SUBMISSION PM & DC BROADHEAD

INVERARY PARK, 40 BROADHEAD LANE, BUNGONIA

OBJECTION TO ARDMORE PARK QUARRY MODIFICATION (MP 07-0155 Mod 3)

VISUAL IMPACTS & LAND DEVALUATION

FIGURE 1

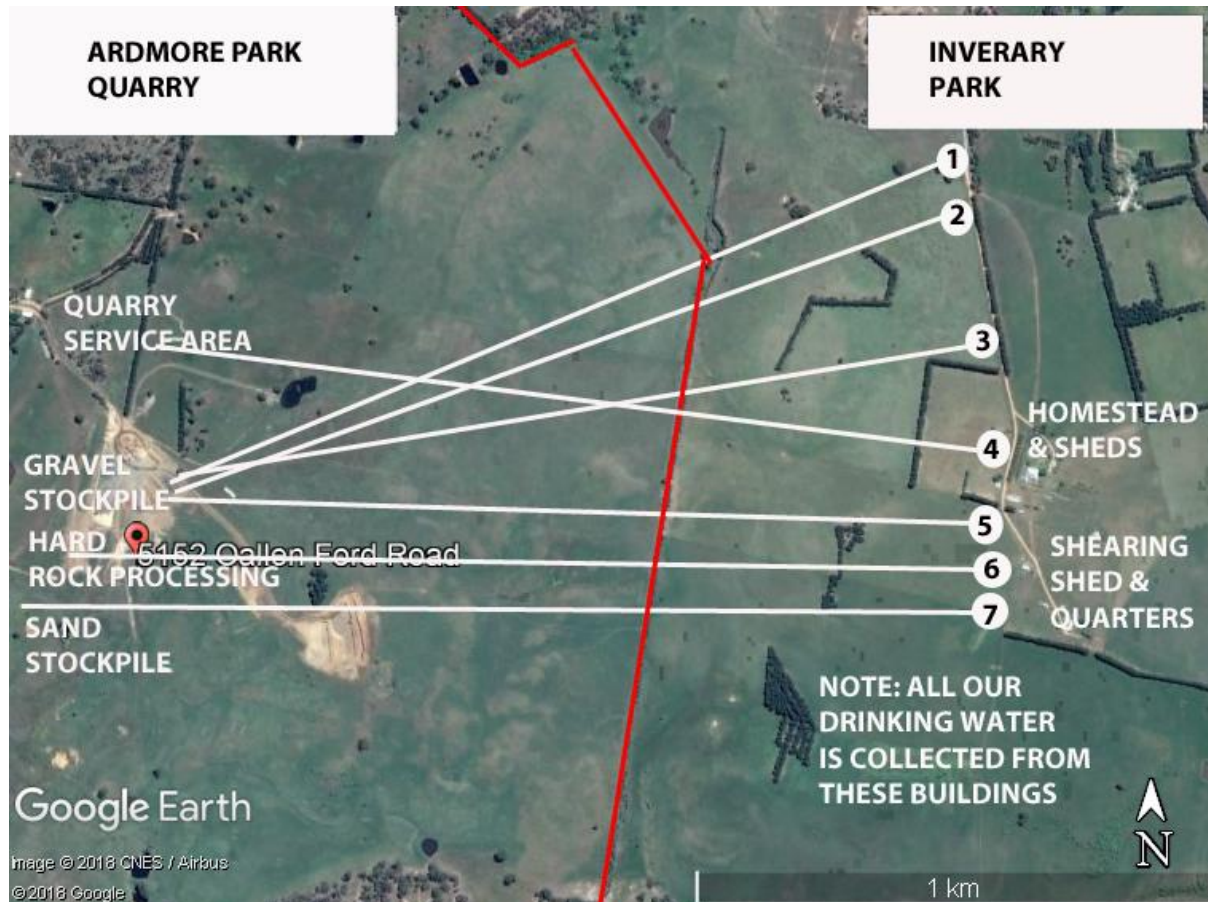
The quarry operations are clearly visible from numerous positions on our property. (See Figure 1 & photos 1-7 following pages) I have marked visible sites of the mine from our mailbox, along our driveway, past the sheds and shearers quarters and up to our shearing shed which are the main areas of our amenities.

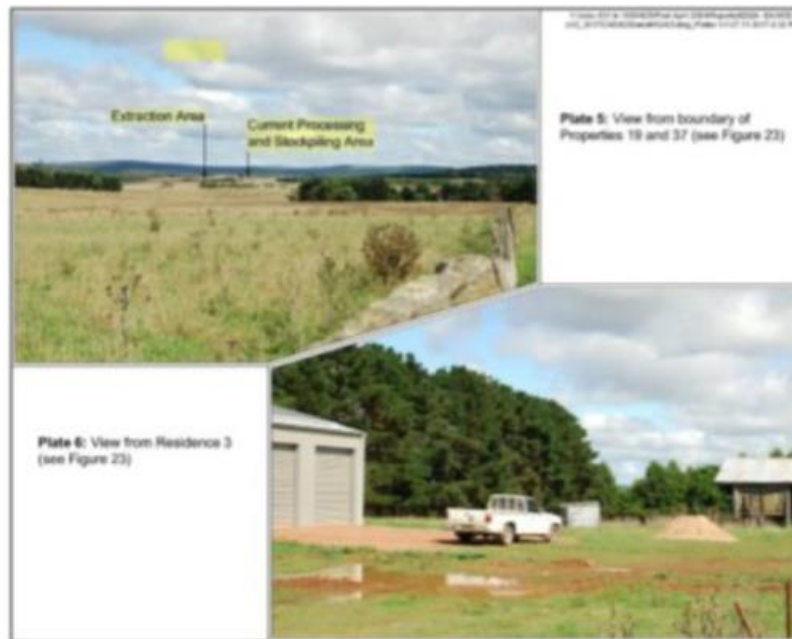
The photograph taken on plate 5 would have been taken around 2010 at the back of our house next to the laundry. This does not clearly reflect our amenity as there is nothing at the back of the house other than a gate that leads to our work shed. To take this photo as showing what we actually see from our property, we believe is misleading and so have included some photos that were taken 12 February 2018.
